Accessibility Assessment Report

Project Name: Macarthur Gardens North R3

Type of Mark Up: Advice based on 50% Design Development

07 PRE-ADAPTABLE
Scale 1:100

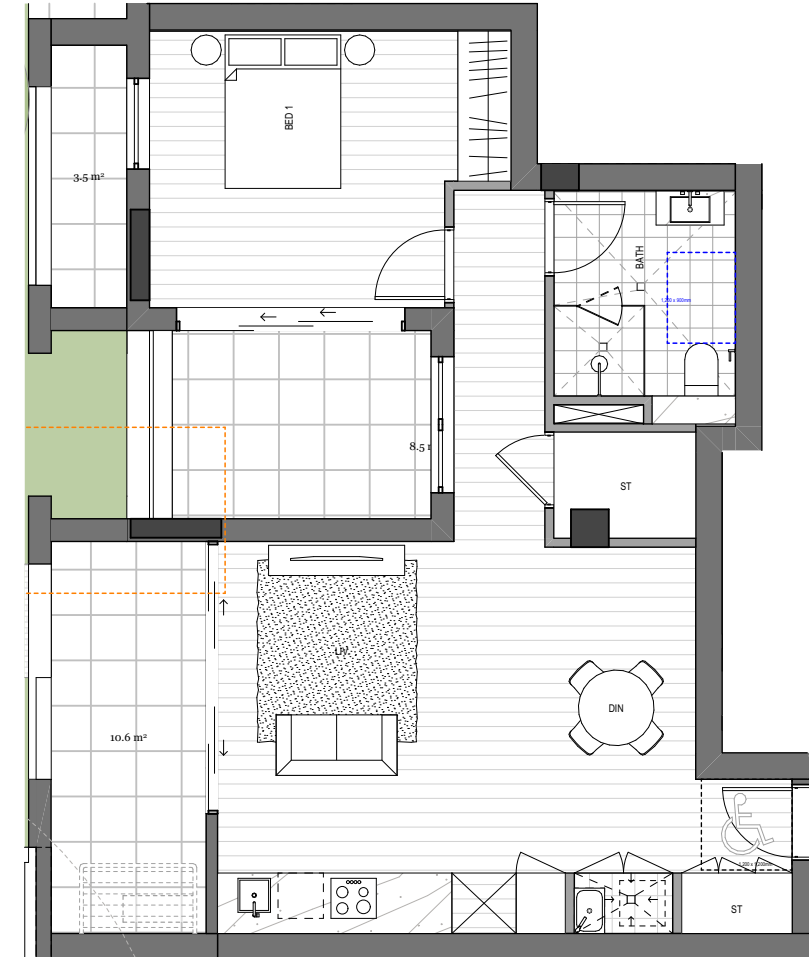
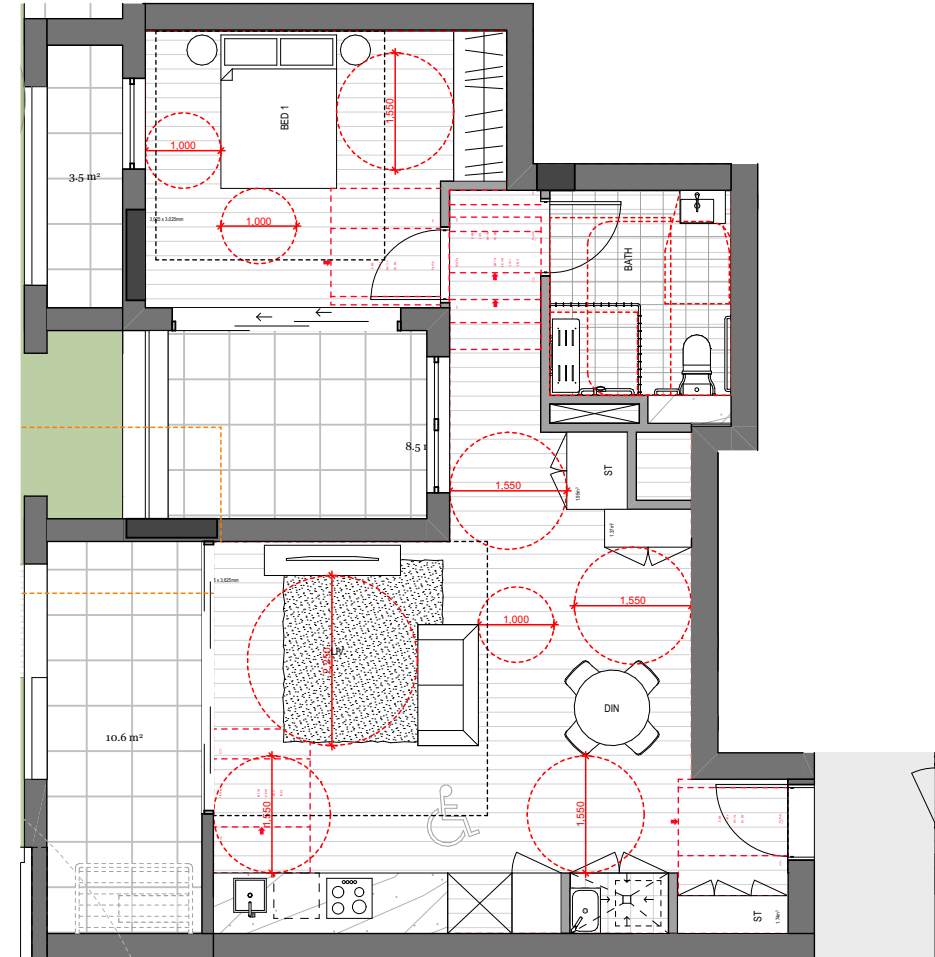
Ensure the minimum shower recess dimension is 1160mm x 1100mm and the waste outlet is positioned in accordance with AS 1428.1 (2021), Figure 47. Floor gradients (refer illustration below)

- To shower recess - 1:60 to 1:80
- To bathroom area - 1:80 to 1:100

Please be aware the requirements of AS1428.1-2021 are less onerous than BCA 2022 clause F2D4

Floor Finishes

- D4D4 of the BCA requires where carpet or any soft flexible materials are used as flooring, the pile height or pile thickness is to be no greater than 11mm and the carpet backing to be not more than 4mm thick.
- Clause 4.3 of AS1428.1-2021 requires matting recessed within a continuous accessible path of travel to have a surface level difference to surrounding materials not more than 3mm for vertical and 5mm for rounded or bevelled edges.
- Clause 4.4 of AS1428.1-2009 specifies grates to have openings no greater than 13mm in diameter. Any slotted openings to be no more than 13mm wide and orientated perpendicular to the dominant direction of travel.

Clause 4.4 of AS4299-1995

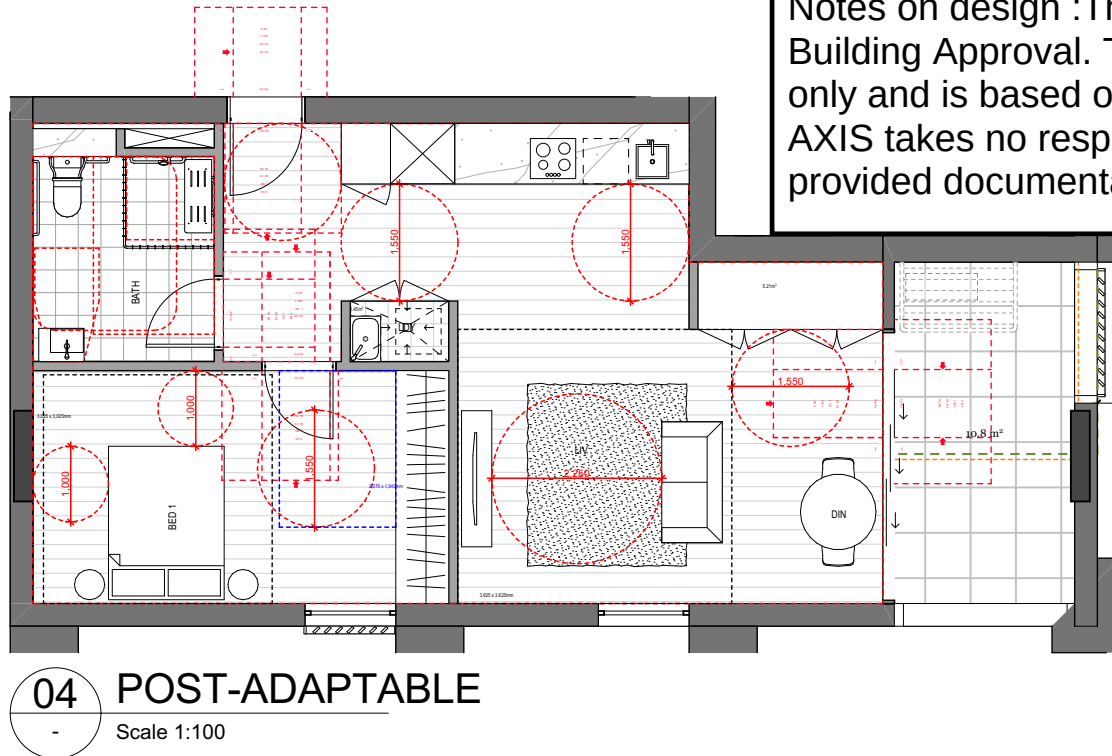
Designers to "potentially comply" with the accessible unisex sanitary facilities comply with AS 1428.1 2021, Section 12 including circulation spaces, exclusion zones, fitting/fixture locations and signage.

01 TYPICAL STUDIO
Scale 1:50

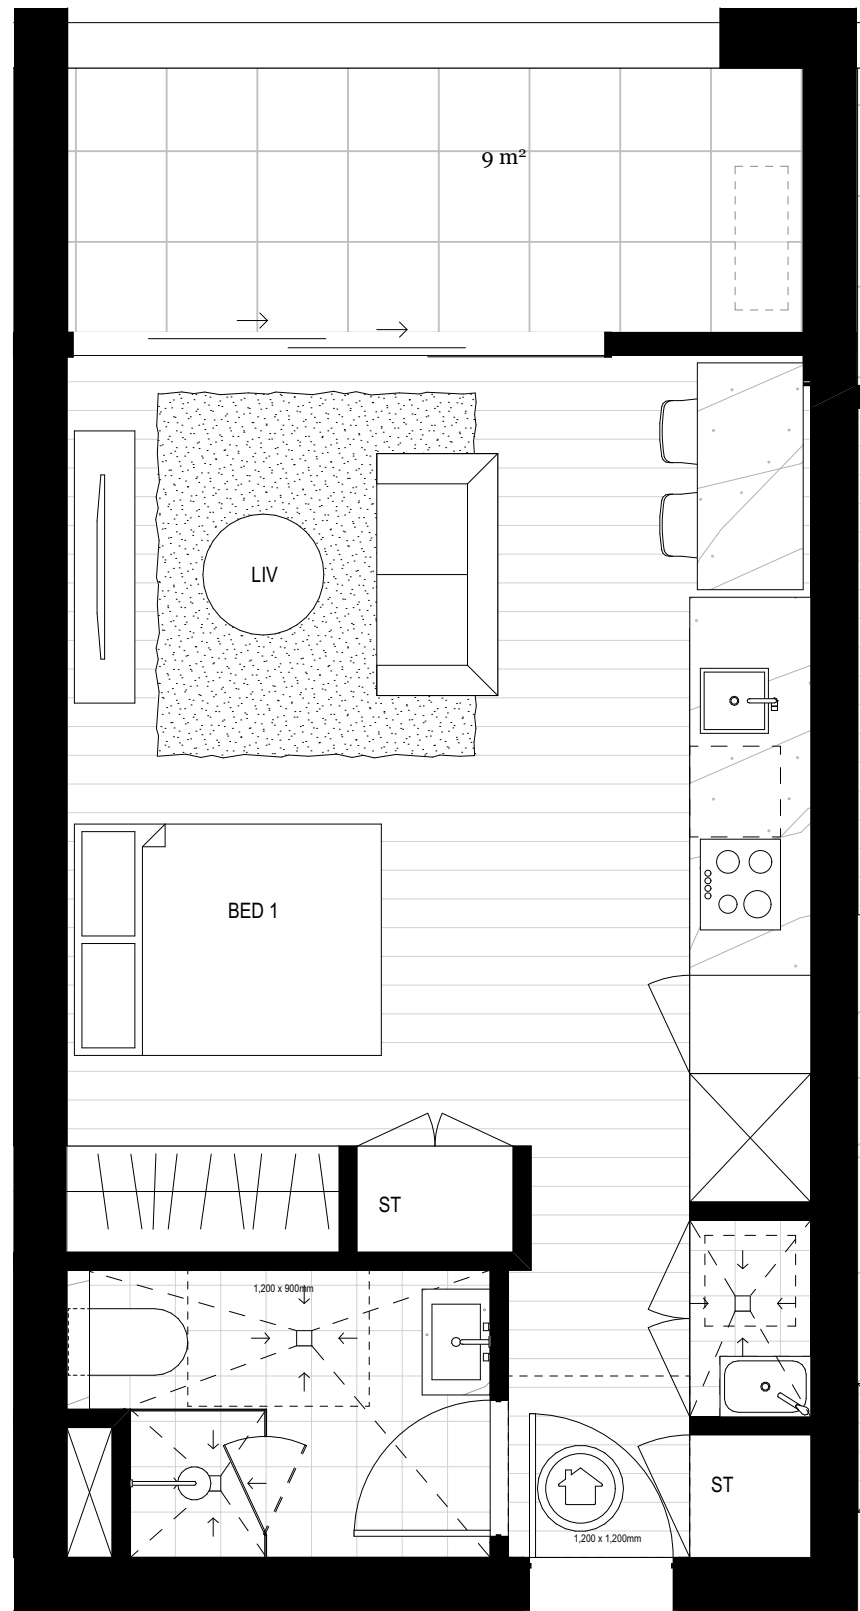
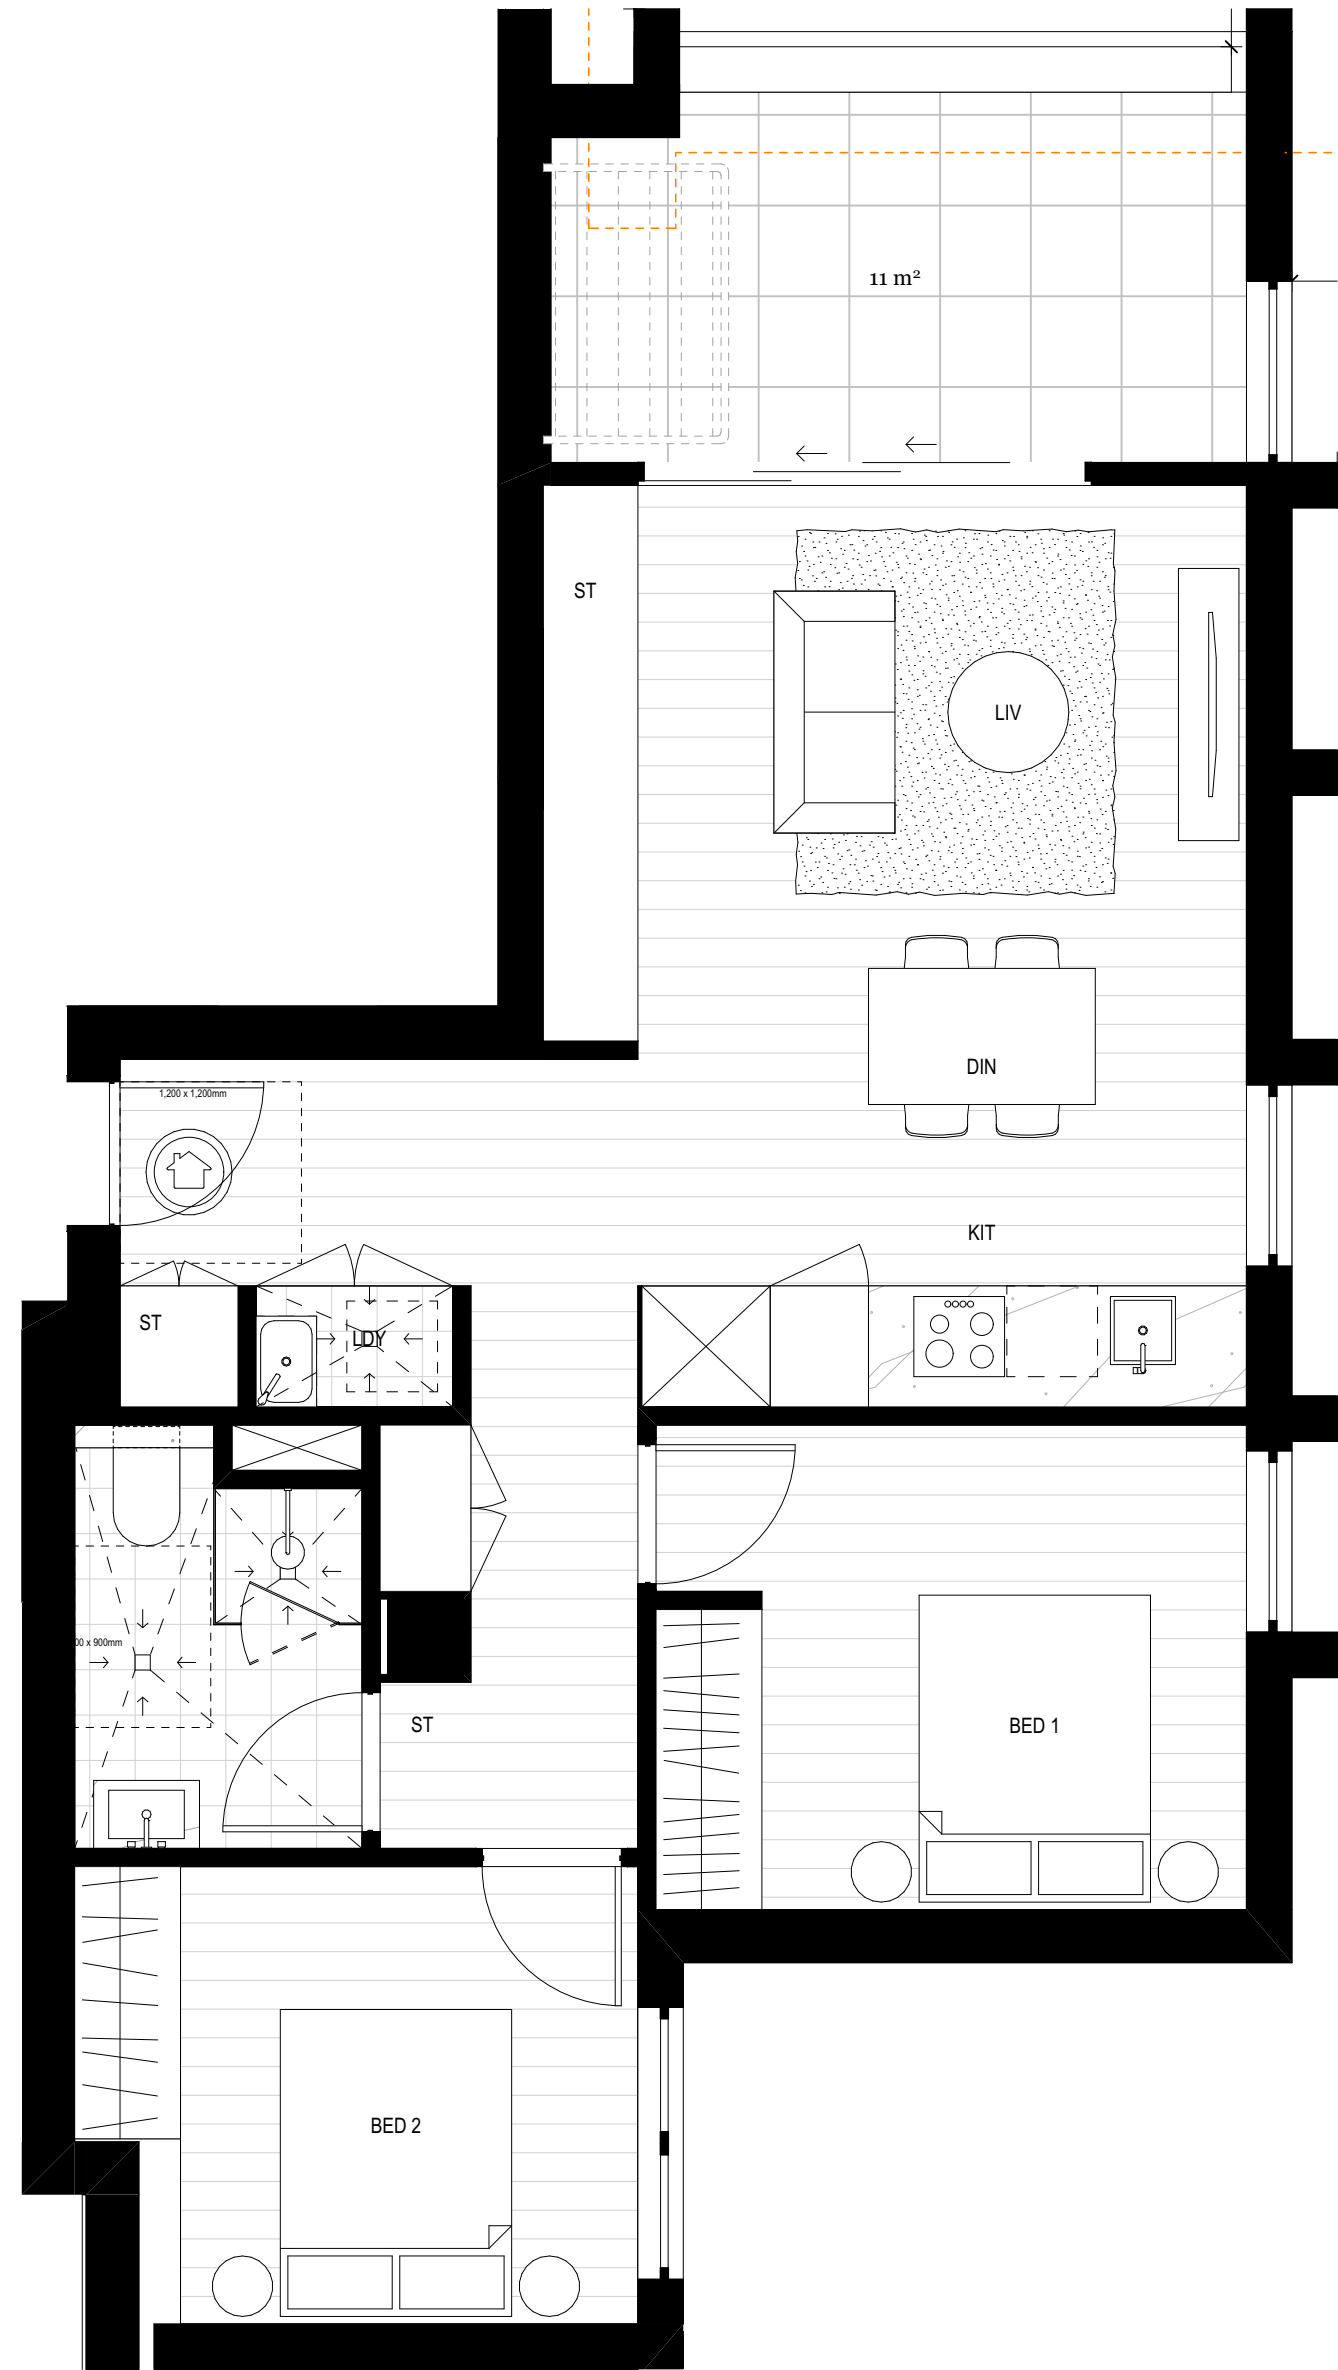
1. A safe continuous and step free path of travel from the street entrance and / or parking area to a dwelling entrance that is level.
2. At least one, level (step-free) entrance into the dwelling.
3. Internal doors and corridors that facilitate comfortable and unimpeded movement between spaces.
4. A toilet on the ground (or entry) level that provides easy access.
5. A bathroom that contains a hobless shower recess.
6. Reinforced walls around the toilet, shower and bath to support the safe installation of grabrails at a later date.
7. Stairways are designed to reduce the likelihood of injury and also enable future adaptation.
